126 FERC ¶ 62,047 UNITED STATES OF AMERICA FEDERAL ENERGY REGULATORY COMMISSION

Project No. 1904-067

ORDER APPROVING DISSOLVED OXYGEN AND TEMPERATURE MONITORING PLAN PURSUANT TO ARTICLE 405

Dissolved Oxygen and Temperature Monitoring Plan

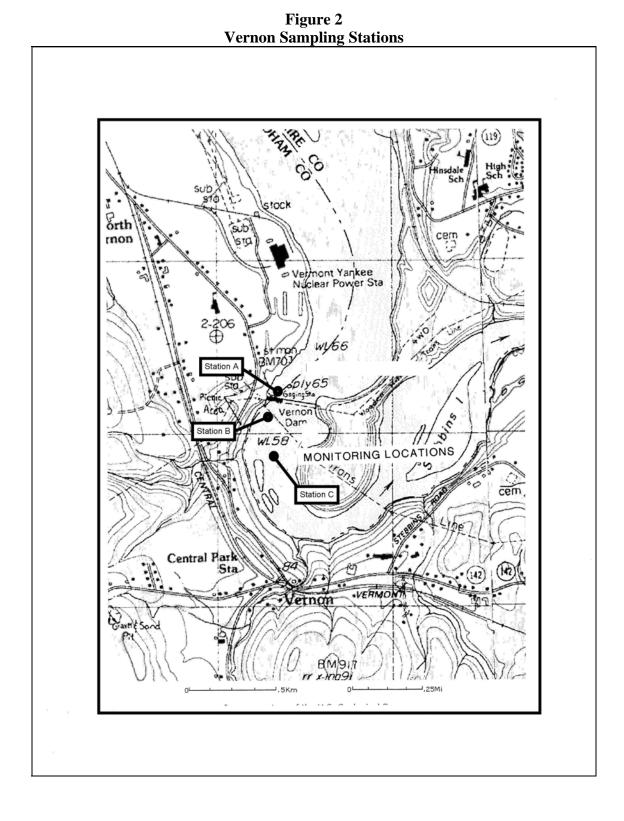
- 1. Section 5.1 describes monitoring stations. Station A may represent the deepest area of the river associated with the Project, based on data from the Vermont Yankee Generic Environmental Impact Statement (EIS) dated December 2006. The water depth near the west bank approximately 0.25 mile upstream from Station A is 39.1 feet. Please include water temperature/dissolved oxygen profiles for each sampling event at Station A, as only water temperature data are available in the EIS.
- 2. Section 5.3 describes QC checks for dissolved oxygen. Please include provisions for a field replicate measurement after every 10th sample. Take the replicate measurement exactly as the original sample (i.e., raise the water quality meter back to the surface, then re-immerse the meter to the depth of the original sample).

Agency Comment	Response
NHDES_1: Section 5. I describes monitoring stations. Station A may represent the deepest area of the river associated with the Project, based on data from the Vermont Yankee Generic Environmental Impact Statement (E]S) dated December 2006. The water depth near the west bank approximately 0.25 mile upstream from Station A is 39.1 feet. Please include water temperature/dissolved oxygen profiles for each sampling event at Station A, as only water temperature data are available in the EIS.	Although TransCanada is not sure of the precise depth at Station A and believes the likelihood of significant depthrelated differences in temperature and dissolved oxygen is low, it is willing to provide water temperature and dissolved oxygen profiles at that location. Section 5.1 has been revised to specify that sampling at Station A will include Temperature and Dissolved Oxygen profile information down to full reservoir depth. Temp/DO profiles will be presented to the NHDES and VTDEC before March 31 of the following year and the issue of whether or not it makes sense to continue collecting profile data for the remaining three sampling events in 2009 will be discussed prior to the actual field season in 2009.

Although TransCanada believes river water at all three of these locations is well mixed, in response to a request from NHDES, The 2008 sampling at Station A will include temperature and dissolved oxygen profile information down to full depth of the reservoir. Temp/DO profiles will be presented to the NHDES and VTDEC before March 31 of the following year. Following the presentation of the information, further consultation with the Agencies prior to the 2009 sampling season will determine if the profile data collection should be continued for the second year of sampling. Operation of the new turbines also is expected to contribute to enhanced mixing downstream. Therefore, sampling at multiple depths in the water column downstream is not warranted, and a single, mid-depth temperature and DO reading would be representative of the entire water column at Stations B and C.
